## Ceratherm 600-2/3 Radiant Warmers

### Installation Instructions for casing, part number 521-7198-3

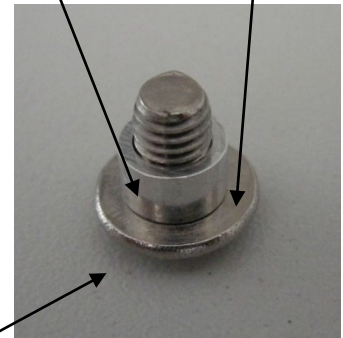
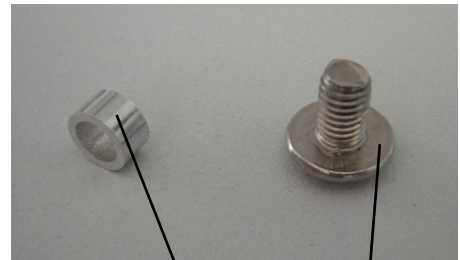
- The new casing (part number: 521-7198-3) has six holes, each with a diameter of 8 mm (previously 6 mm).

- The existing six mounting screws (M5 x 8) should be assembled with the supplied 7.0 x 1.0 x 4.0 support sleeves (part number: 521-79940100.10, set of 6).
- Each screw should then be fitted, together with a support sleeve.

- Using a screwdriver, tighten by hand until the screw stops. The screw head rests on the sleeve (not on the casing).
